Samuels & Associates
136 Brookline Ave
Boston MA 02215

September 25, 2019

Subject: Notice of Project Change – Washington Village

Image 1 - 3D model of the Proposed Development Used for the Wind Tunnel Study

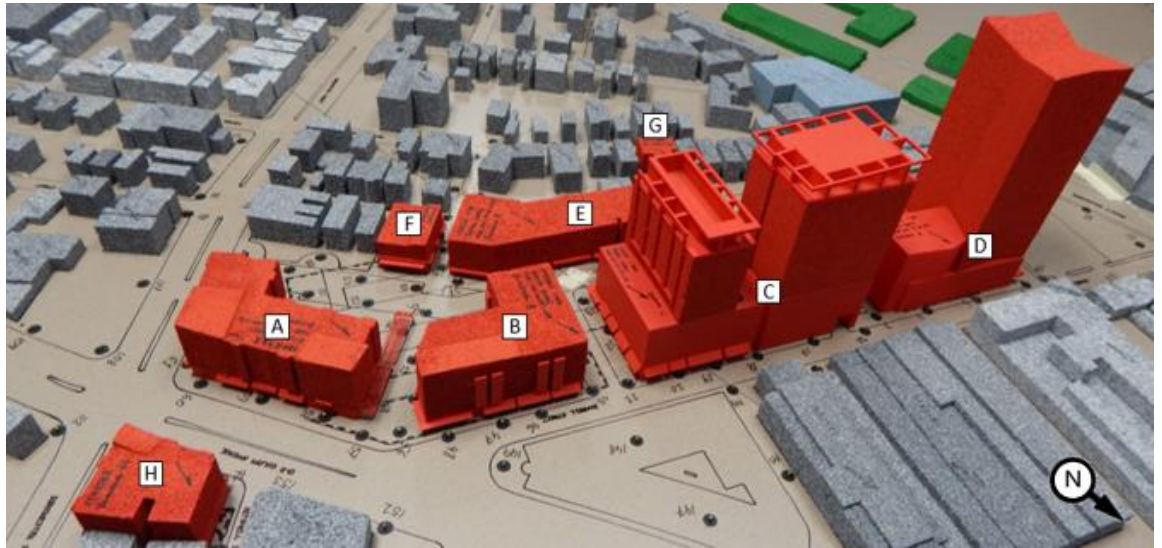
Following the wind tunnel study, RWDI received updated drawings on August 14, 2019. Images 1 and 2 show the building massing's used for the wind tunnel test and a rendering of the modified design, respectively. Based on a review of the new information received, we understand that Buildings A and B, as identified in Image 1, will now be combined into one building, while the open green space will be relocated to the east of Building C. The new building will also increase in height by approximately 15 feet. No other massing changes were noted.

With the modified design in place, the predicted wind conditions at grade around the site are anticipated to remain generally consistent with the previous findings. Slightly higher wind activity is predicted in the open green space and on the north side of Building E due to increased exposure, reduced east tower setback of Building C and channeling of prevailing winds. However, wind speeds are anticipated to be suitable for active pedestrian use (i.e., a mean speed category of 'Walking'). Furthermore, the wind conditions in the courtyard behind Building A are anticipated to improve. Wind conditions elsewhere on the site are not anticipated to be negatively affected by the modified design.

Image 2 - Rendering of the Proposed Development Based on New Drawings

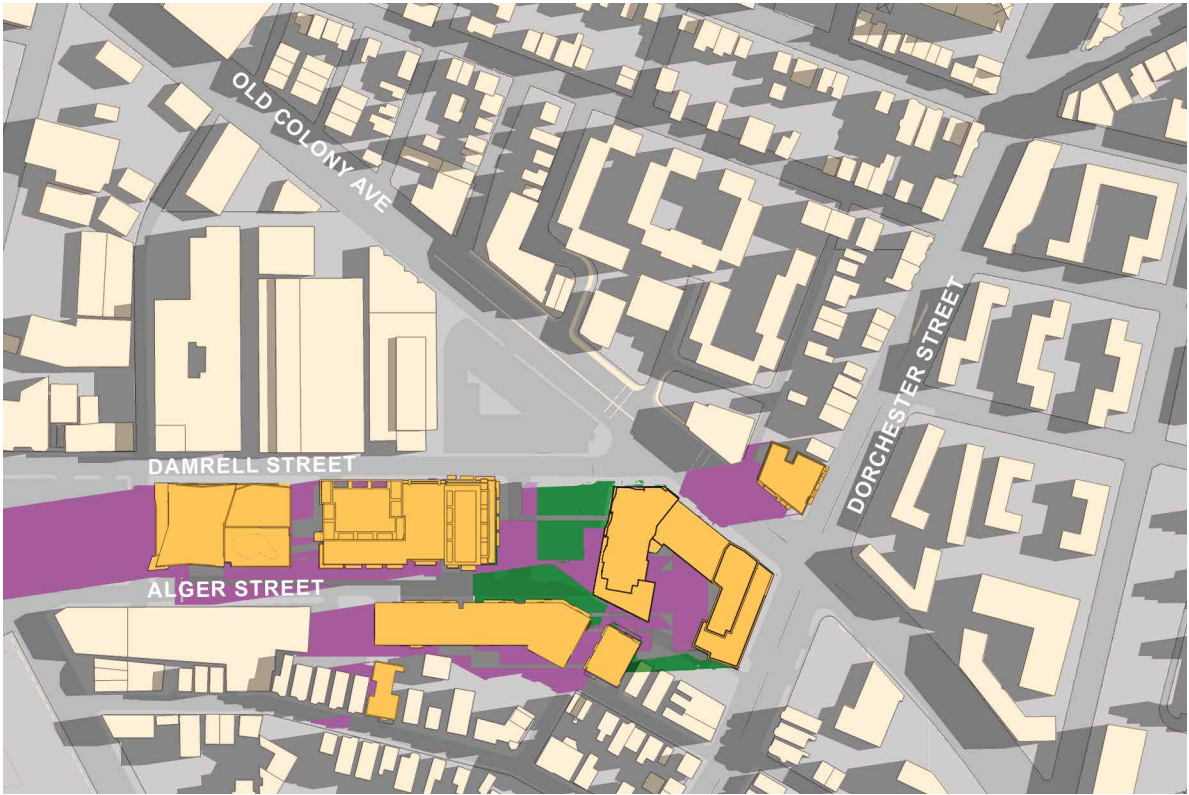
The proposed landscaping shown in Image 2 was not included in the wind tunnel study and would help reduce wind speeds during the summer when adequate foliage is present.
